April 9, 2014
L-2014-033
10 CFR 50.90

Re: Turkey Point Nuclear Plant, Units 3 and 4
Docket Nos. 50-250 and 50-251
Renewed Facility Operating Licenses DRR-31 and DPR-41
License Amendment Request No. LAR-229
Application for Technical Specification Change Regarding Risk-Informed Justifications
for the Relocation of Specific Surveillance Frequency Requirements to a Licensee
Controlled Program

License Amendment Request No. LAR-229

Subject: Application for Technical Specification Change Request Regarding Risk-Informed Justifications for the Relocation of Specific Surveillance Frequency Requirements to a Licensee Controlled Program

Insert 1

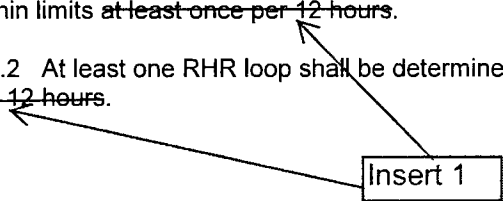
4.4.1.4.1.1 The secondary side water level of at least two steam generators when required shall be determined to be within limits ~~at least once per 12 hours~~.

4.4.1.4.1.2 At least one RHR loop shall be determined to be in operation and circulating reactor coolant ~~at least once per 12 hours~~.

Insert 1

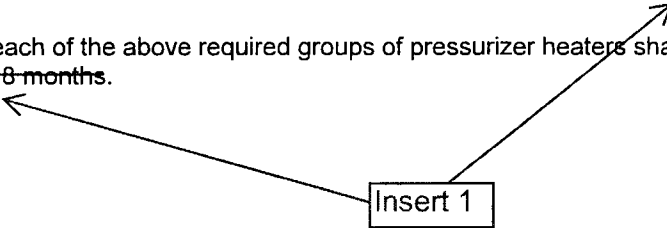
4.4.3.1 The pressurizer water volume shall be determined to be within its limit ~~at least once per 12 hours.~~

4.4.3.2 The capacity of each of the above required groups of pressurizer heaters shall be verified to be at least 125 kw ~~at least once per 18 months.~~

Insert 1

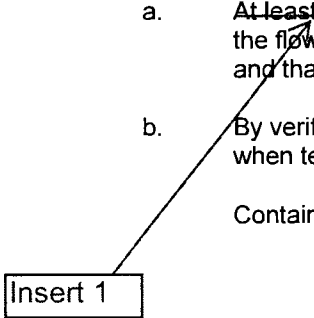
- a. ~~At least once per 31 days~~ by verifying that each valve (manual, power-operated, or automatic) in the flow path that is not locked, sealed, or otherwise secured in position, is in its correct position and that power is available to flow path components that require power for operation;
- b. By verifying that on recirculation flow, each pump develops the indicated differential pressure, when tested pursuant to Specification 4.0.5:

Insert 1

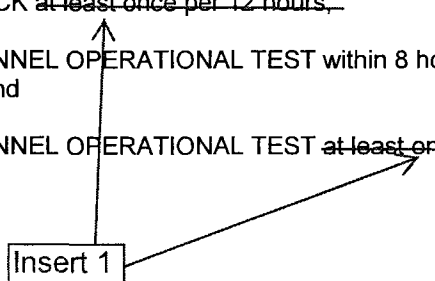
- a. A CHANNEL CHECK ~~at least once per 12 hours,~~
- b. An ANALOG CHANNEL OPERATIONAL TEST within 8 hours prior to the initial start of CORE ALTERATIONS, and
- c. An ANALOG CHANNEL OPERATIONAL TEST ~~at least once per 7 days.~~

Insert 1

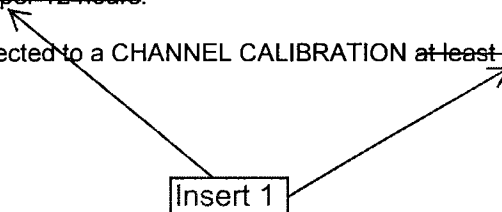
4.9.8.1.1 At least one RHR loop shall be verified in operation and circulating reactor coolant at a flow rate of greater than or equal to 3000 gpm ~~at least once per 12 hours.~~

4.9.8.1.2 The RHR flow indicator shall be subjected to a CHANNEL CALIBRATION ~~at least once per 18 months.~~
